REGULATION 95 CONCERNING THE APPROVAL OF VEHICLES WITH REGARD TO THE PROTECTION OF THE OCCUPANTS IN THE EVENT OF A LATERAL COLLISION

Addendum 94: Regulation No. 95

Regulation No. 95

Figure 1: Measurement of Vb, V1, V2

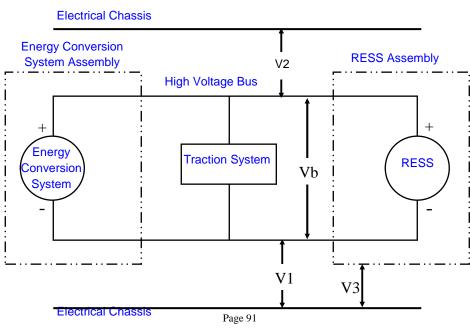
V3 is not used in the text ? To discuss the test during the meeting

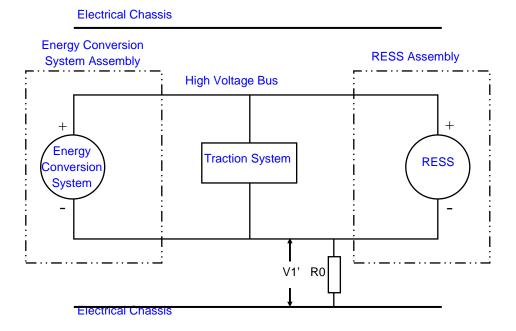
The measurement shall be made after 5 seconds (Test difficult to perform) of the vehicle coming to rest after each crash test.

It is acceptable for vehicle manufacturer to elect to calculate or simulate this value instead of measuring this after the crash.
